ANADROMOUS WATERS CATALOG/ATLAS
CORRECTION FORM

MAP: Bering Glacier A-4/A-5

NOMINATION NUMBER: C-1 / C-5 03 212

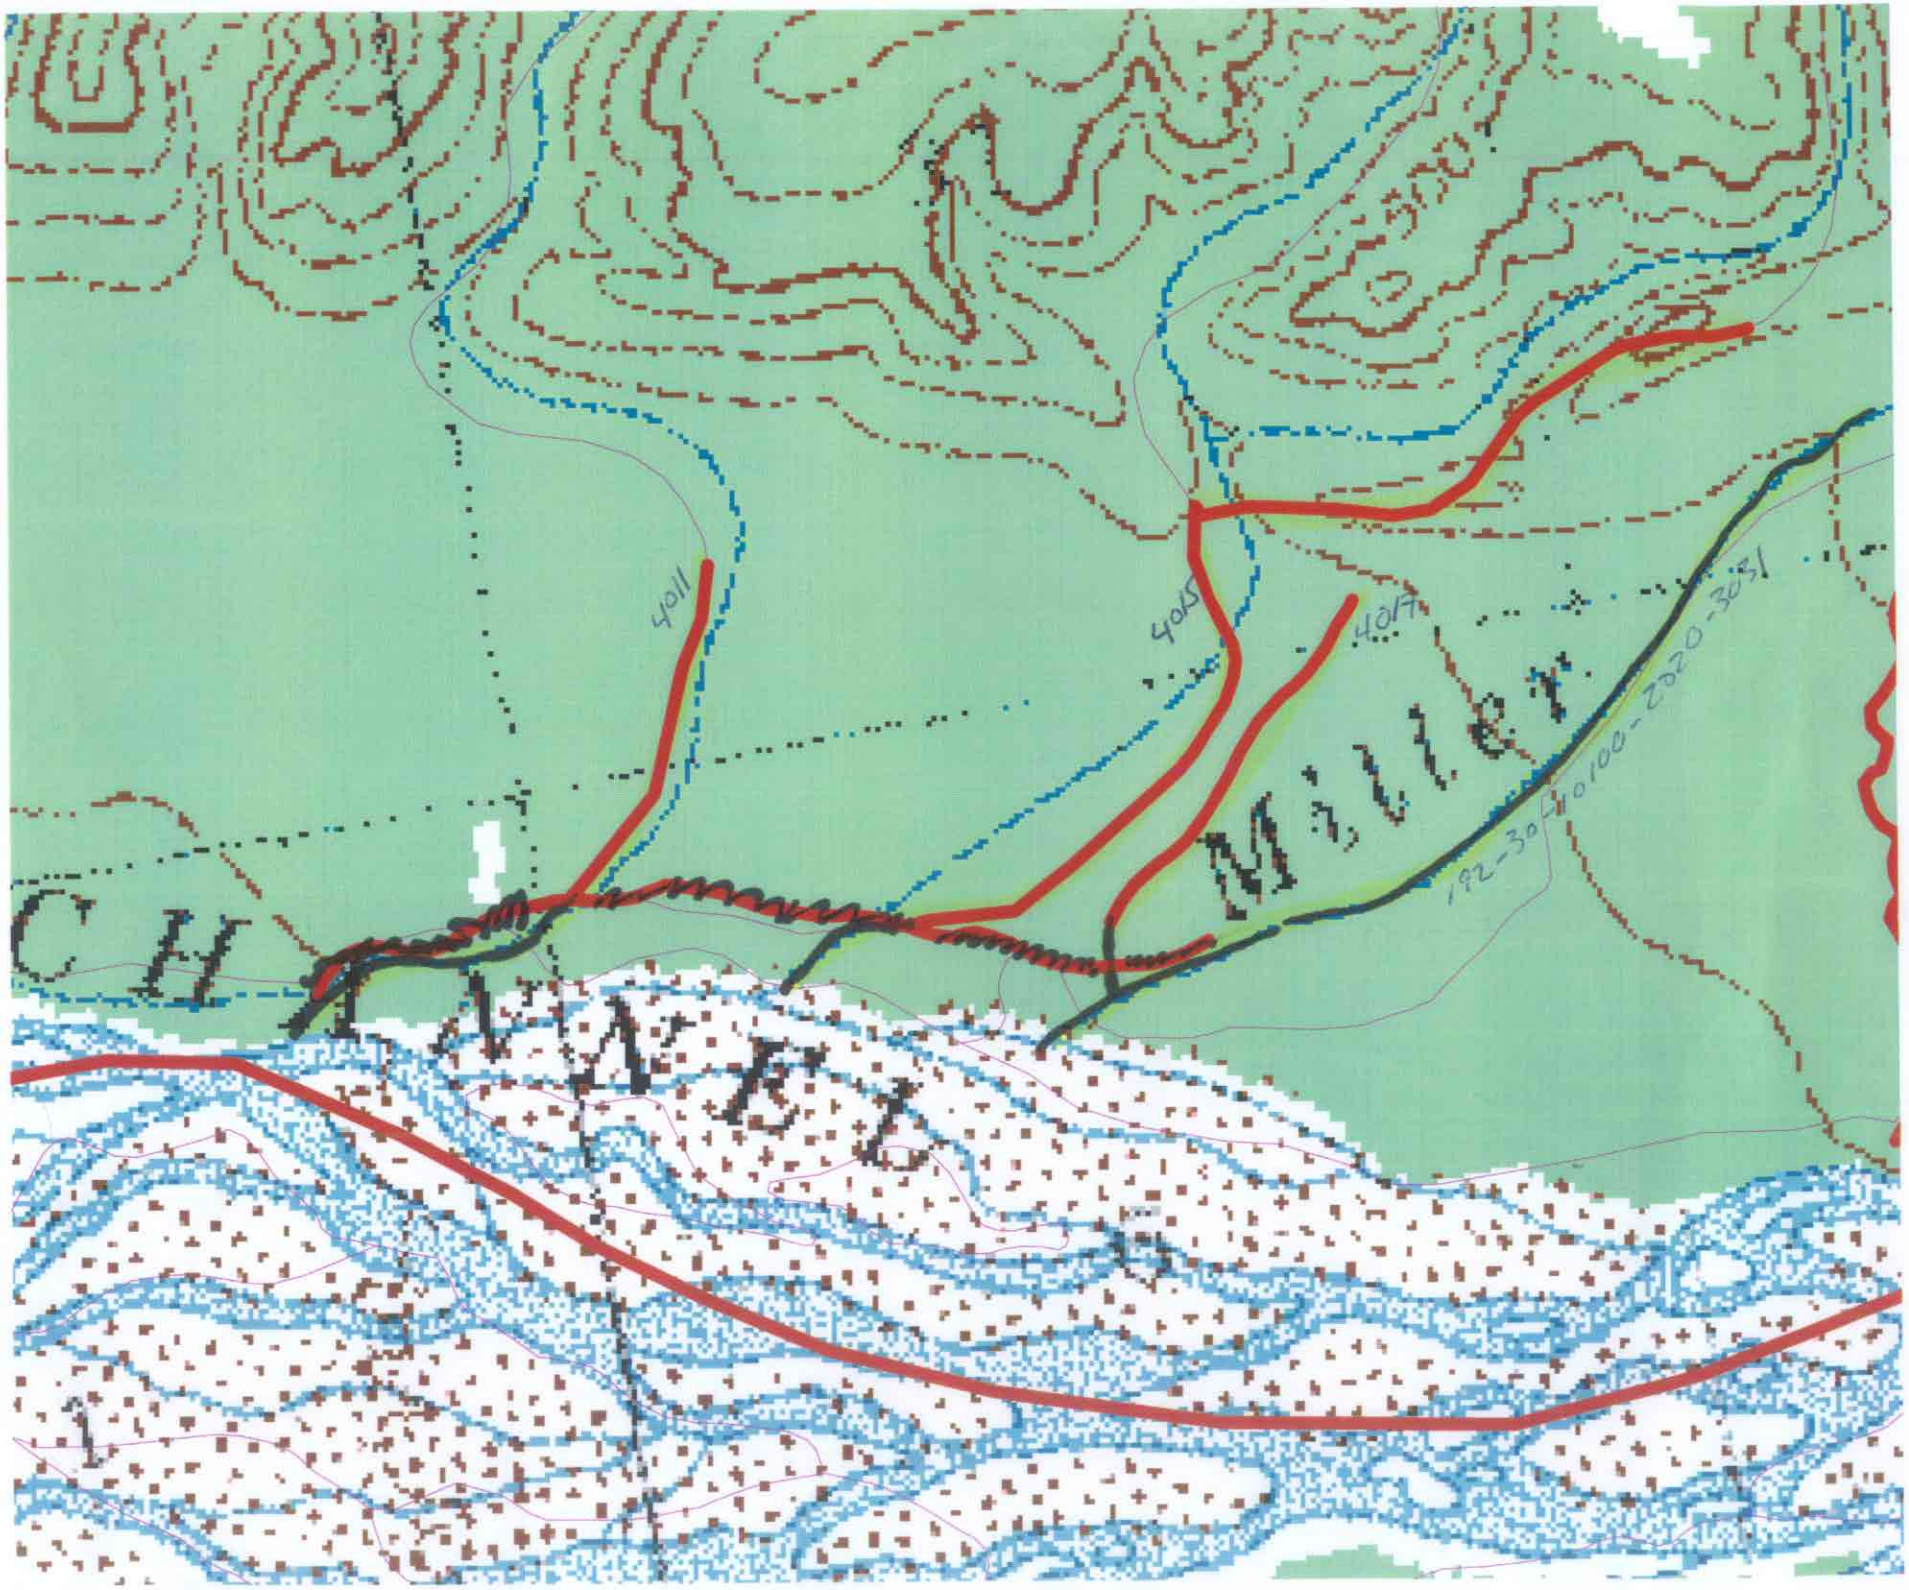
DESCRIBE CHANGE(S): Miller Ck course has changed - eliminate part of stream to west, mouth mostly due South

Change to 192-30-10100-2020-9011 From 192-30-10100-2020-3031-4011

Change to 192-30-10100-2020-9015 From 192-30-10100-2020-3031-4015
